**ADDENDA #2
AVIS RENT A CAR
JETPORT BOULEVARD, PORTLAND, MAINE**

**AVIS RENT A CAR
JETPORT BOULEVARD
PORTLAND, MAINE**

ADDENDUM #1

Avis Rent a Car

Project No.
 W0768
 SKS-01

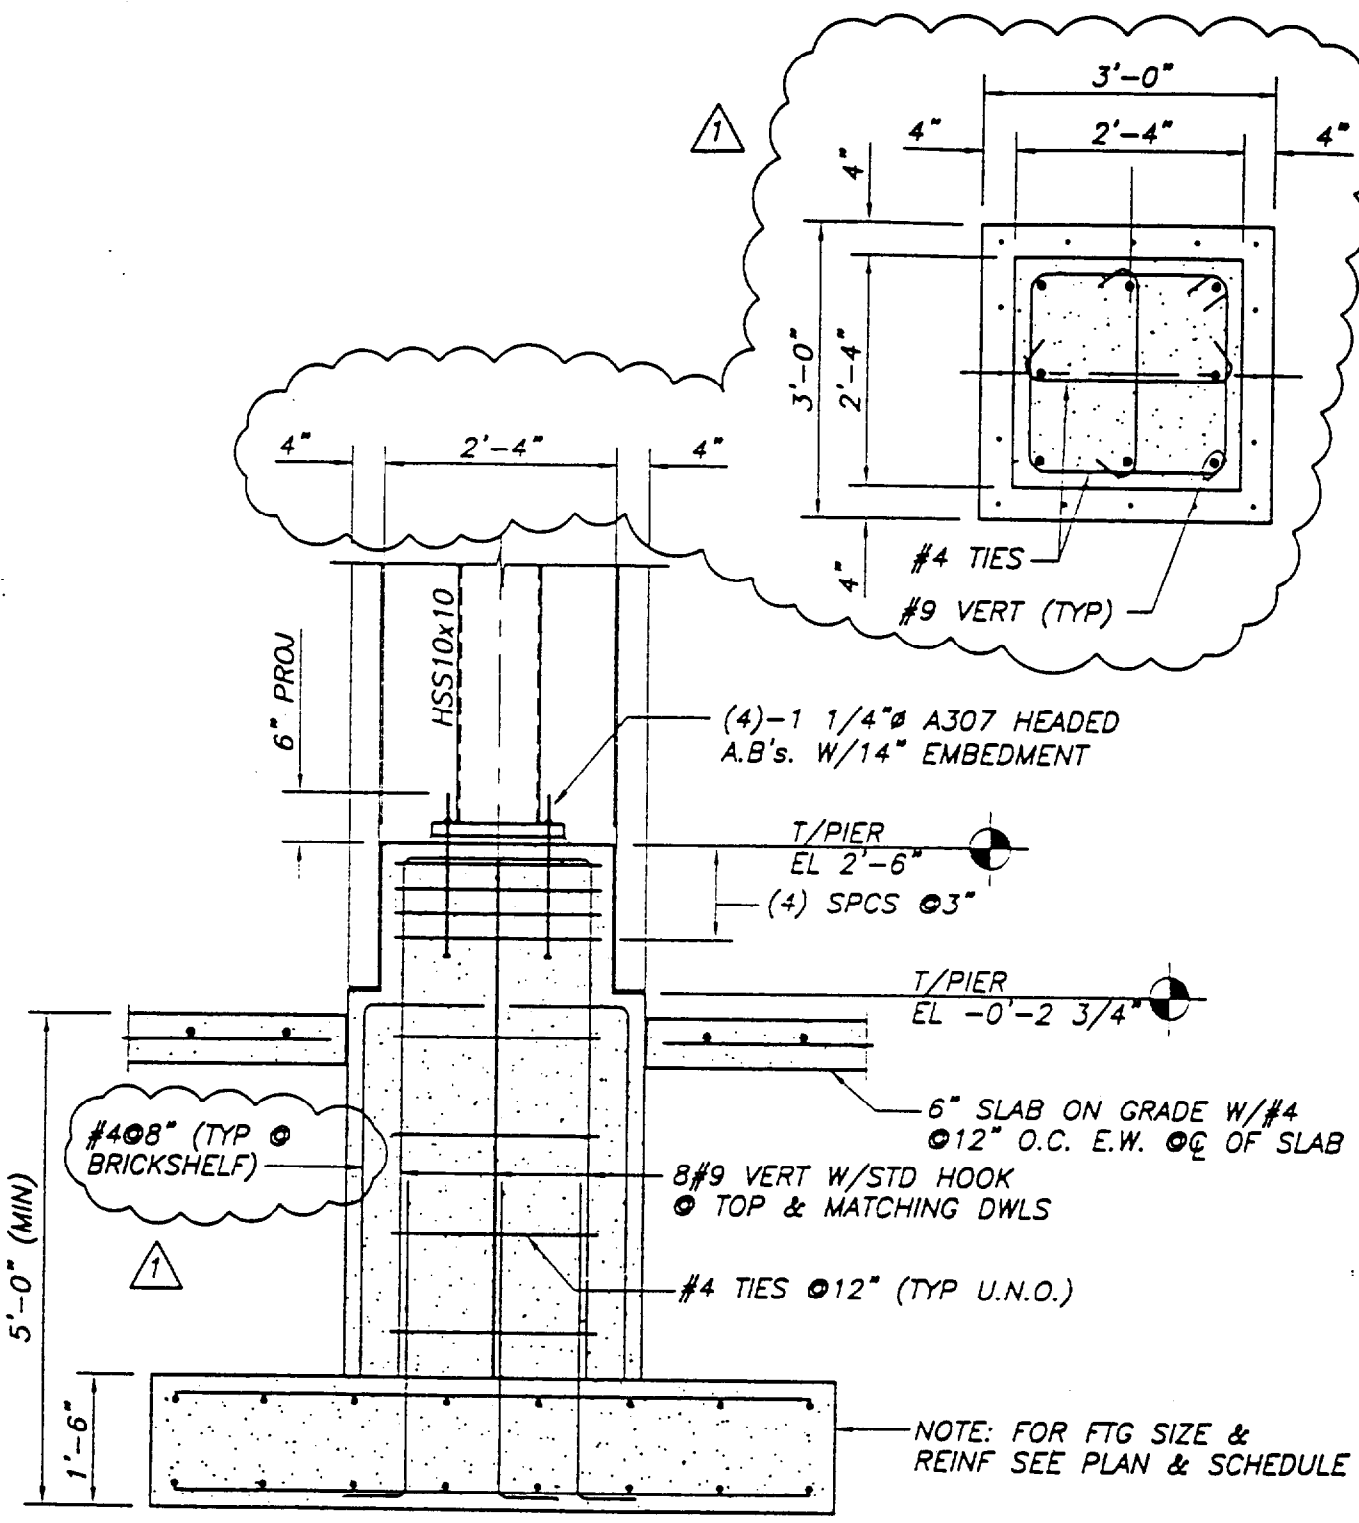
PART FDN PLAN @ FUEL ISLAND
 N.T.S.

REF DWG S1

SKS-02

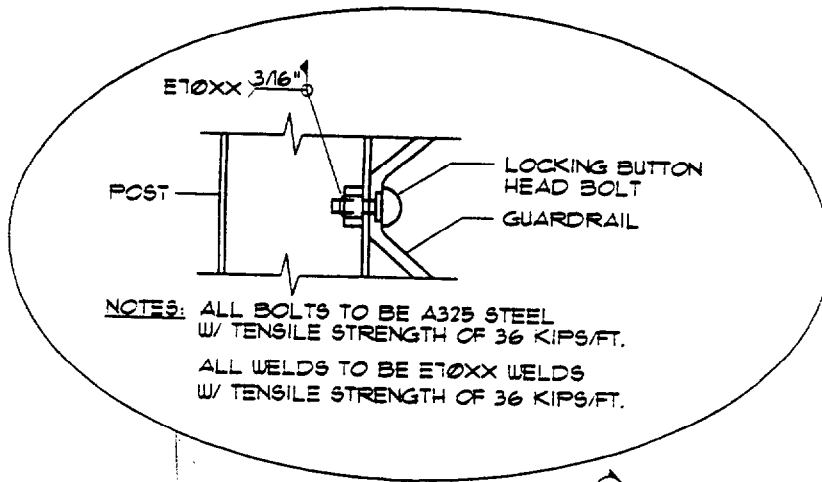
REF SECT 10/S3

SECTION

TYP. GUARDRAIL DETAILS

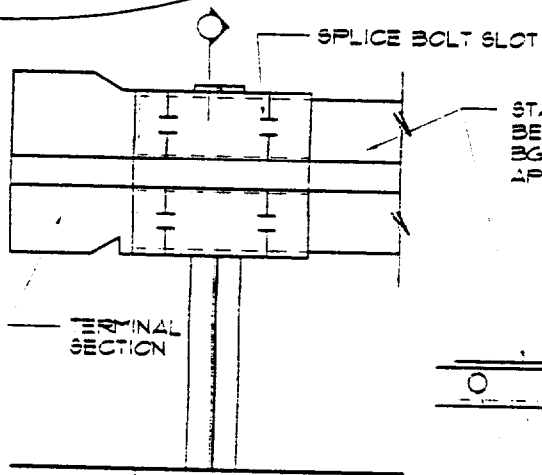
34. DWG A400 details are on DWG A600 details 2 and 5 and DWG A200 detail 3 and 4.
35. Install 40 mil w.r. grace ice and watershield on all roofs – entire surface and fascia.
36. Car wash floor shall be hardened concrete surface.
37. Install guard rail around entire perimeter of chain link fence except at ledge and steep bak at northwest of lot, see enclosed detail.
